service bulletin

M78-3

SUBJECT: GOVERNOR OIL TRANSFER COLLAR SLEEVES, RETAINING CLIPS AND CLEARANCES

AFFECTED: O-470, IO-470, TSIO-470, IO-520 and TSIO-520 Engines which incorporate Oil Transfer Collar Assembly TCM Part Number 626739

**FIGURE 1**

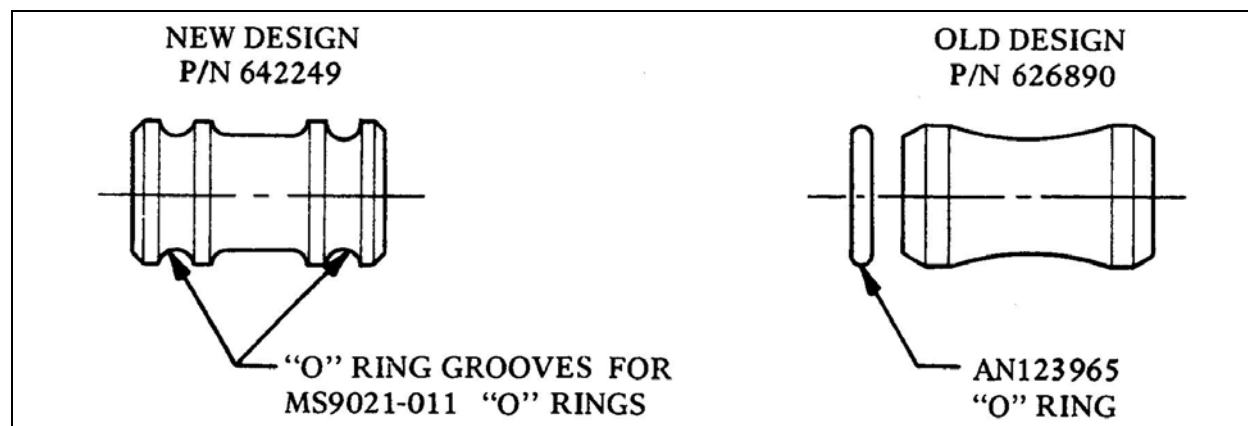
The Teledyne Continental Motors Aircraft Service Department is pleased to announce the availability of an improved governor oil transfer sleeve TCM part number 642249 to be used with two (2) each MS9021-011 "O" rings (as shown in Figure 1) in all of the above mentioned model engines which incorporate TCM part number 626739 governor oil transfer collar assembly. These parts replace transfer sleeve part number 626890 and "O" ring part number AN123695.

Installation of the new sleeve and "O" ring assembly is recommended at the next overhaul period to reduce the possibility of governor oil leakage between the crankcase and transfer collar assembly.

FIGURE 2

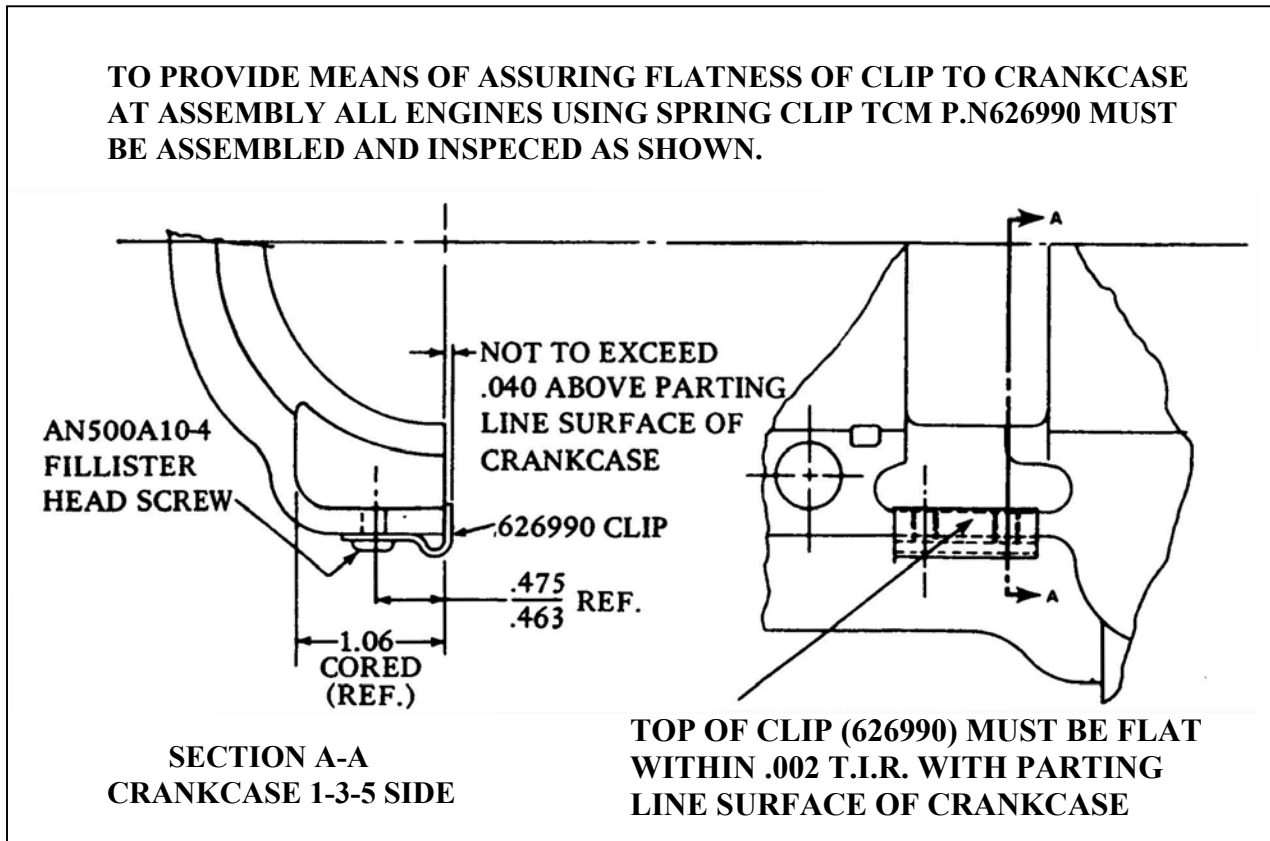
CAUTION: Early design crankcases which incorporate the 90 degree transfer collar spring clip TCM part number 626990 as shown in Figure 2 must continue to use that clip with the following caution:

If the transfer collar spring clip is assembled to the crankcase in an excessively raised position, it can cause loading of the transfer collar into the crankshaft resulting in collar scoring and loss of governor control.

To provide a means of assuring flatness of this clip to the crankcase at assembly, inspect and maintain the tolerance as shown in Figure 2. If the required tolerance cannot be attained by tapping the clip with a plastic hammer, discard the clip and select another.
